**(Product Change Notification)**

PCN# 071621

In efforts to improve our quality and match industry standards NorComp has changed the geometry of the hardware associated with the part numbers listed on the subsequent page.

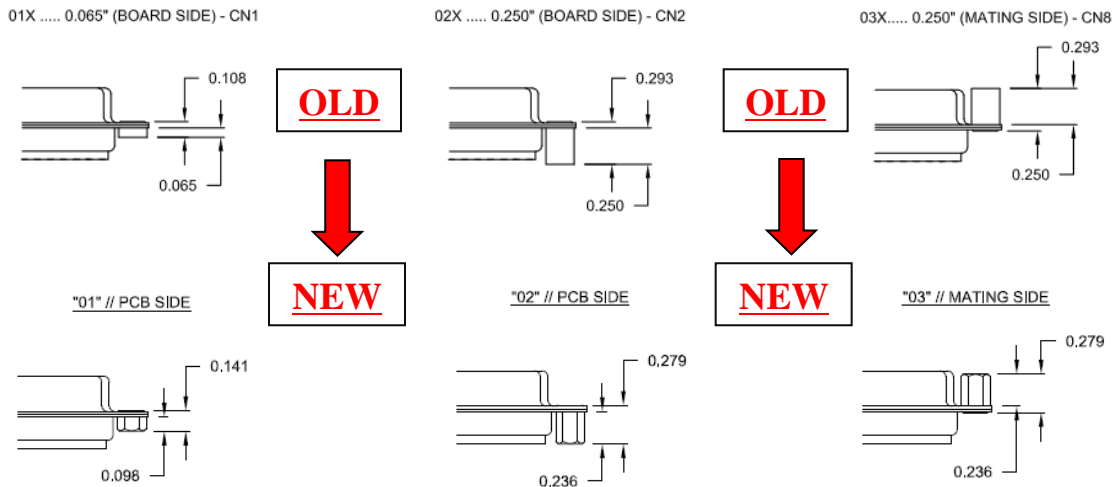
The hardware change pertains to shape and length for the following hardware options shown below. The illustrations below provide a better understanding of the change (all units are in inches). If you have any technical questions, please reach out to [eng@norcomp.net](mailto:eng@norcomp.net).

The last date to purchase the old variation will be Tuesday, February 28<sup>th</sup>, 2023. All orders placed on/after Wednesday March 1<sup>st</sup>, 2023 will use the new variant shown above.
